BCA ASSESSMENT REPORT

**SCARLETT RESTAURANT
HARBOUR ROCKS HOTEL
34 HARRINGTON ST SYDNEY NSW**

Revision 0
25 September 2017
Project No.: 170343

Figure 1: Concept Plan
Source: Welsh + Major

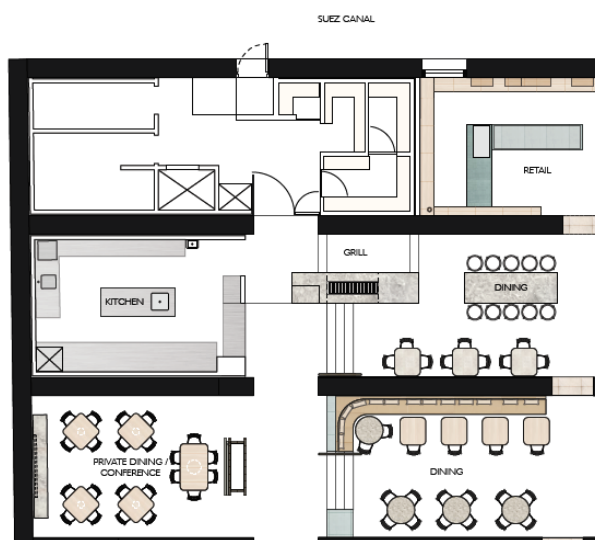
The proposed development comprises alterations to Level 2 (Nurses Walk Level) of the existing Harbour Rocks Hotel building to facilitate an expansion of the existing Scarlett Restaurant.

Figure 2: Existing Fire Wall

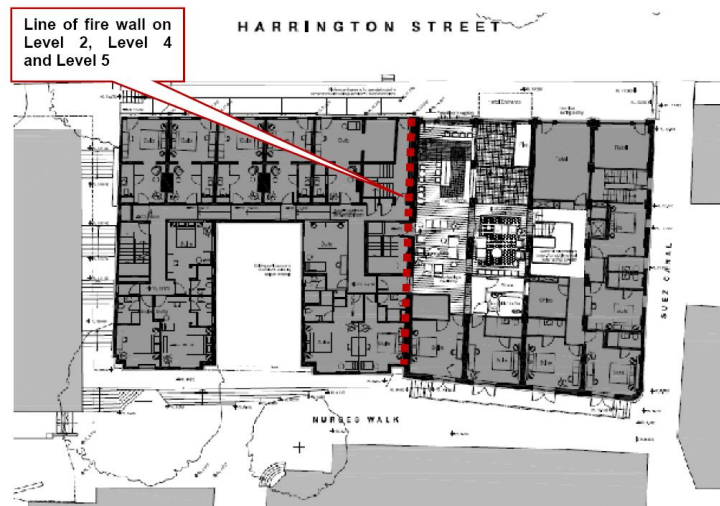
5. Clause C2.2 – General Floor Area and Volume Limitations: We note that the area in which the proposed works are situated is within the maximum floor area and volume limitations permitted under Table C2.2 of the BCA. Furthermore, we note that there is no alterations proposed to the existing fire wall separating the restaurant from the hotel part.

The integrity of the fire wall is to be maintained as part of the proposed works.

In addition to the above, it is noted that there is currently additional fire separation in the vicinity of the kitchen area. Further review of the fire separation is required to determine purpose of the separation and whether it needs to be maintained or altered as part of the new works.

Figure 4: Nominated Exits

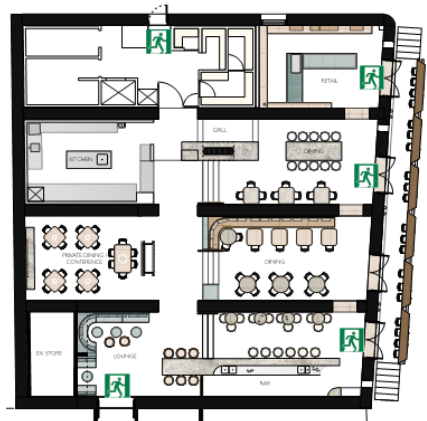
10. Clause D1.2 – Number of exits: The minimum number of exits serving the subject storey comply BCA clause D1.2.

Exits serving the subject area are identified below.
